Project	IEEE 802.16 Broadband Wireless Access Working Group < <a href="http://ieee802.org/16">http://ieee802.org/16</a> >	
Title	In-band Non-transparent Relay Frame Structure	
Date Submitted	2006-03-05	
Source(s)	<p>Kanchei (Ken) Loa, Yi-Hsueh Tsai, Yung-Ting Lee, Chih-Chiang Hsieh, Shiann-Tsong Sheu, Hua-Chiang Yin, Frank C.D. Tsai, Youn-Tai Lee, Heng-Iang Hsu          Institute for Information Industry          8F., No. 218, Sec. 2, Dunhua S. Rd., Taipei City, Taiwan.</p> <p>Hang Zhang, Peiying Zhu, Mo-Han Fong, Wen Tong, David Steer, Gamini Senarath, Derek Yu, Mark Naden, G.Q. Wang          Nortel          3500 Carling Avenue          Ottawa, Ontario K2H 8E9</p> <p>Gang Shen, Kaibin Zhang          Alcatel-Lucent, Research &amp; Innovation          388#, Ningqiao Road, Shanghai, China.</p> <p>[add co-authors here]</p>	<p>Voice: +886-2-2739-9616  <a href="mailto:loa@iii.org.tw">loa@iii.org.tw</a></p> <p>Voice: +1 613 7631315  <a href="mailto:WenTong@nortel.com">WenTong@nortel.com</a>  <a href="mailto:pyzhu@nortel.com">pyzhu@nortel.com</a></p> <p>Voice: 86-21-58541240-8194  <a href="mailto:gang.a.shen@alcatel-sbell.com.cn">gang.a.shen@alcatel-sbell.com.cn</a></p>

# In-band Non-tra

*Figure xxx—Example of minimum configuration for an in-band non-transparent relay frame structure*

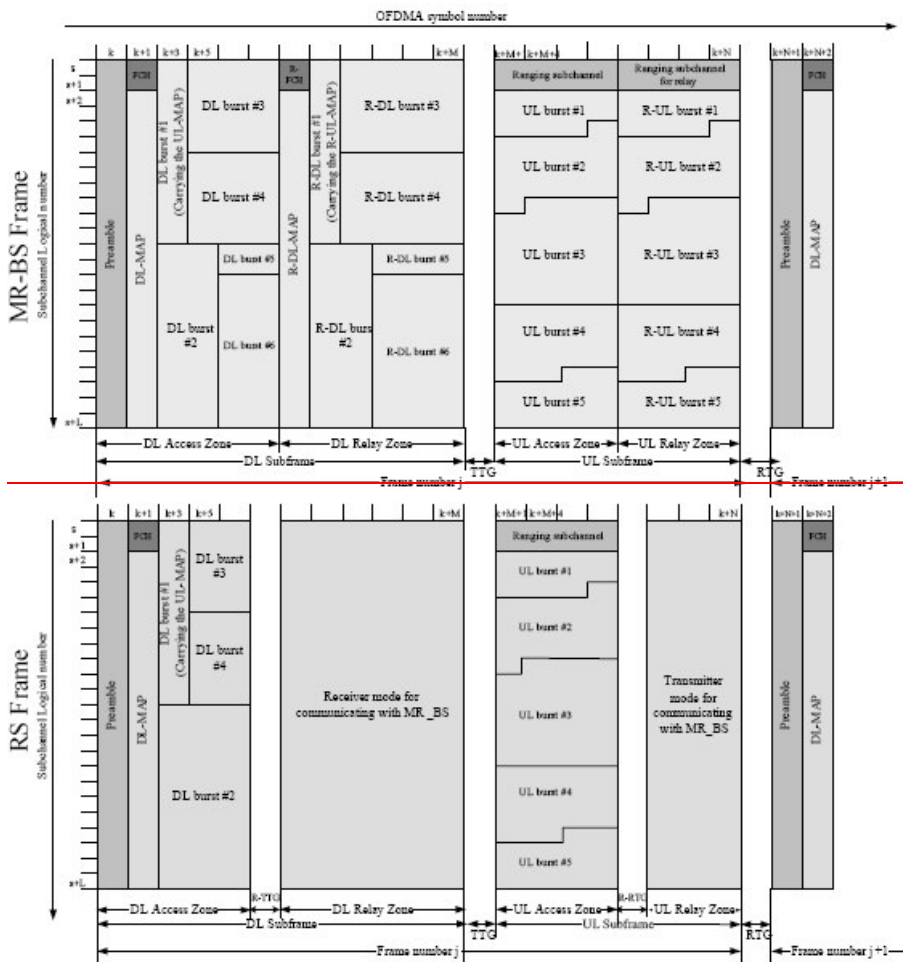
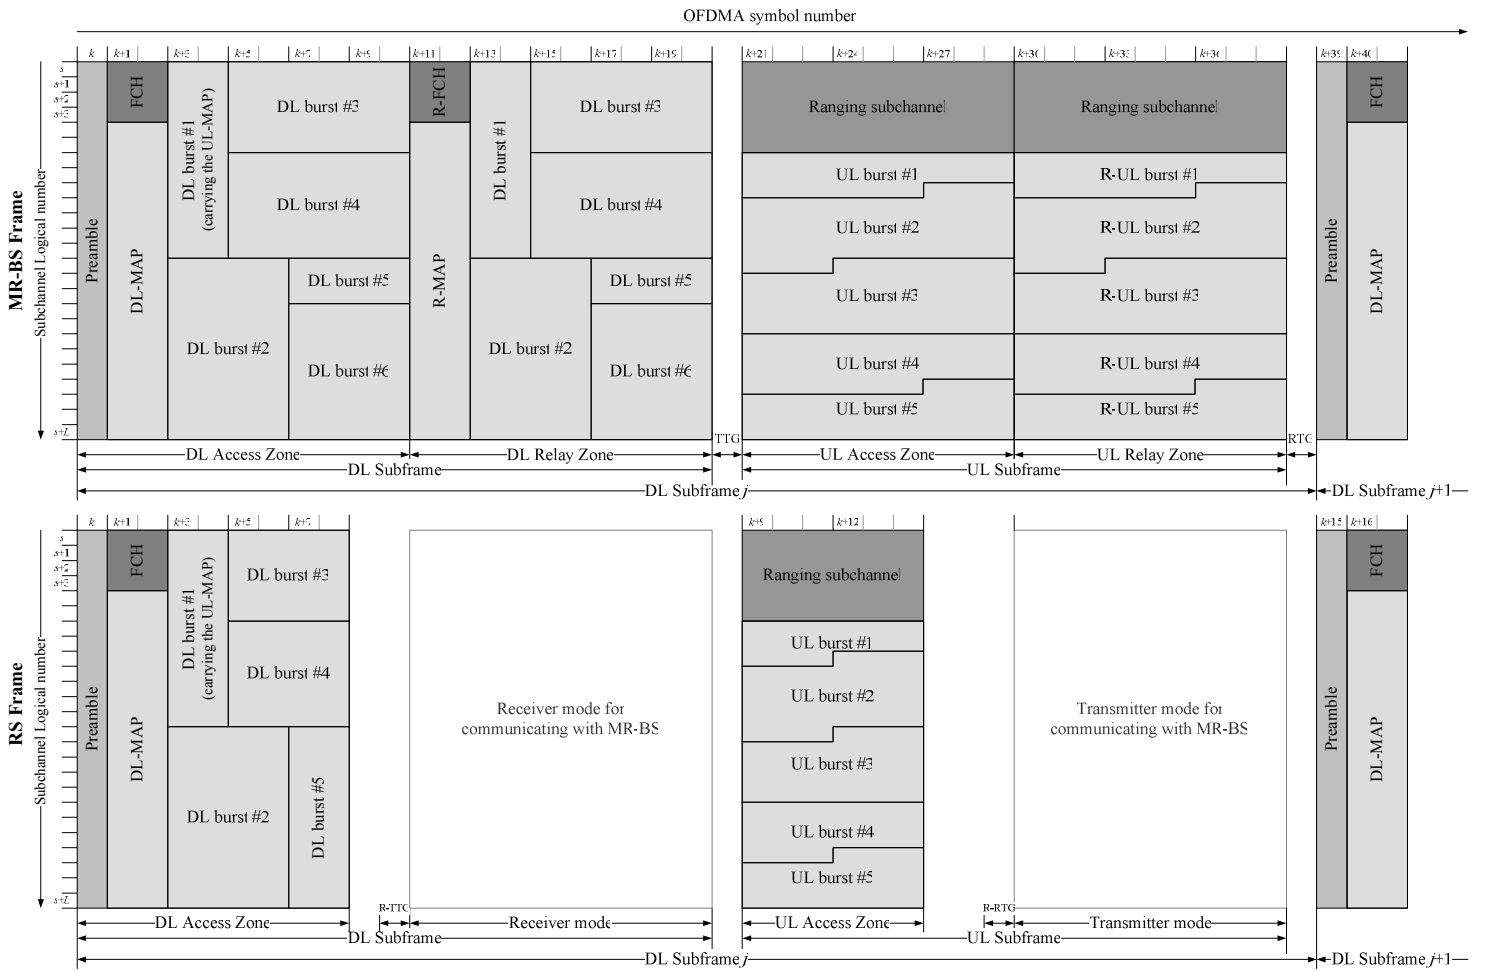
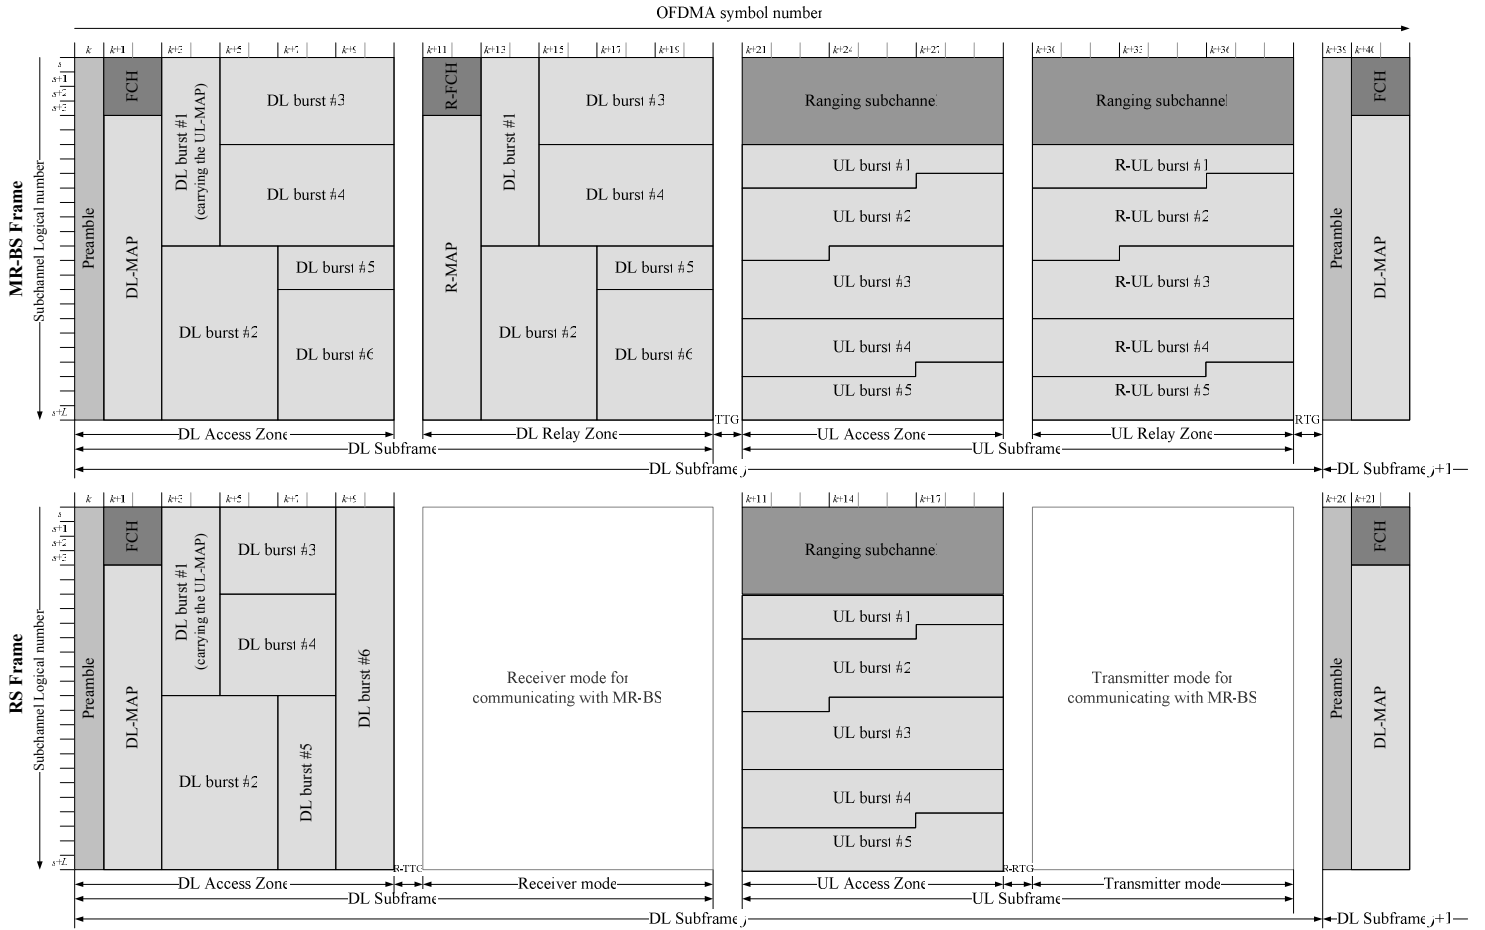
[Change the figure in section 8.4.4.7.2 “Frame structure for non-transparent mode” as indicated:]

[Replace Figure xxx with Figure yyy as follows:]

Remedy 1

Remedy 2
